# DEPARTMENT HEAD COMMENTS

Special Permit Site Plan Review

Post Road Realty LLC 107 Simarano Drive Map 116, Parcels 5, 11, 12 Green District (Executive Residential)

Subject:Green District CommentsAttachments:IMG\_0823.JPG; IMG\_0821.JPG

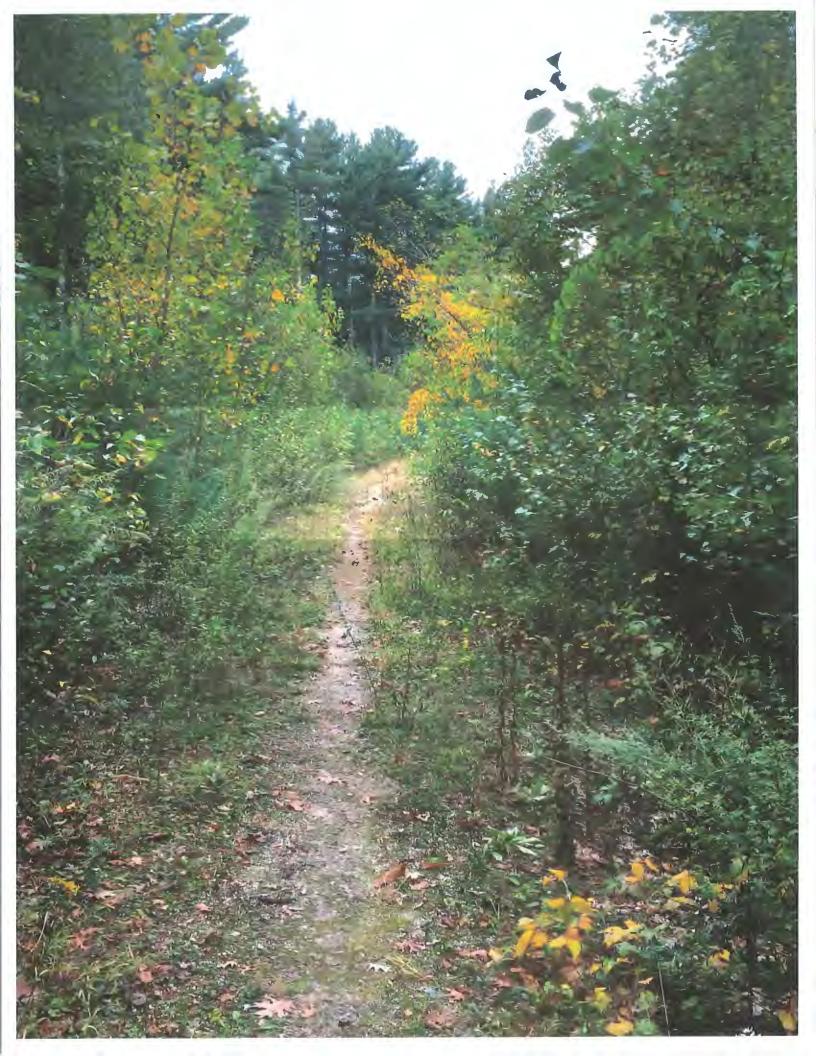
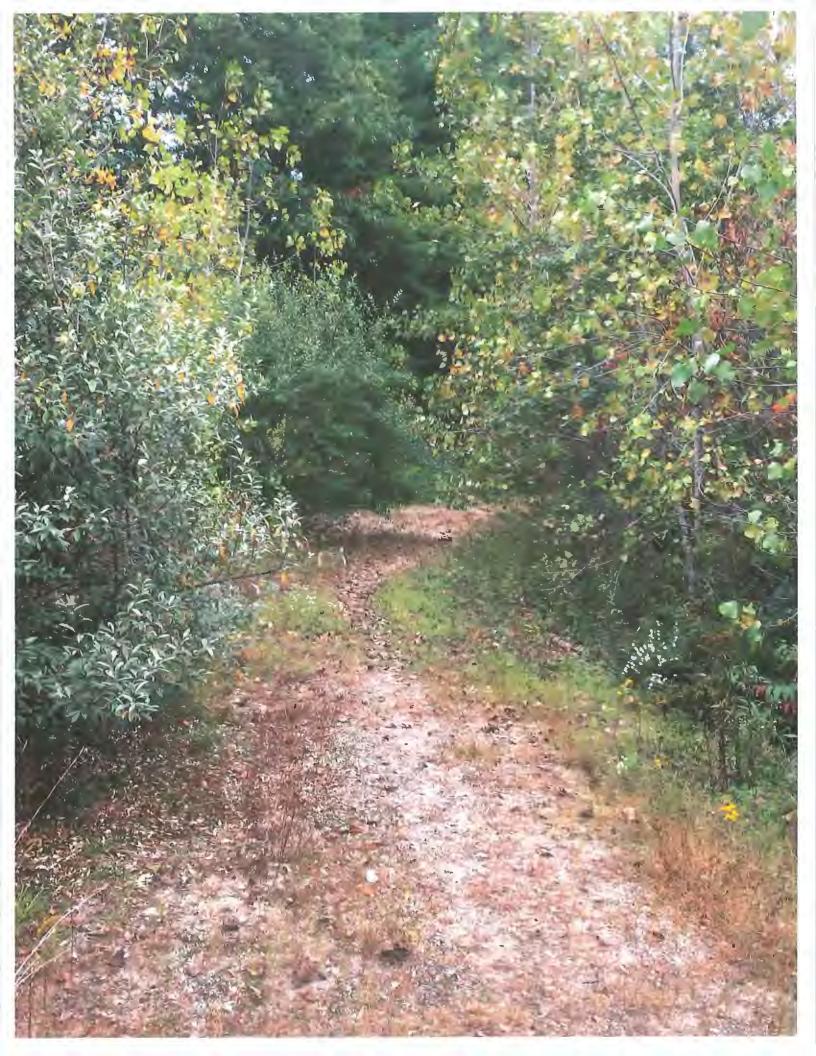
At this time the concern that I have of the Green District Development is the looping emergency access road It is my opinion and suggestion that the loop road is constructed and bituminous concrete surface applied. Originally this roadway is the emergency access road for the Stonegate development and was to be maintained as such As per the site visit and pictures, it is clear that this emergency access way has never been maintained to a level that emergency vehicles could navigate.

I therefore suggest that the loop roadway from Simarano Drive to Cedar Hill be constructed and paved suitable for vehicular traffic
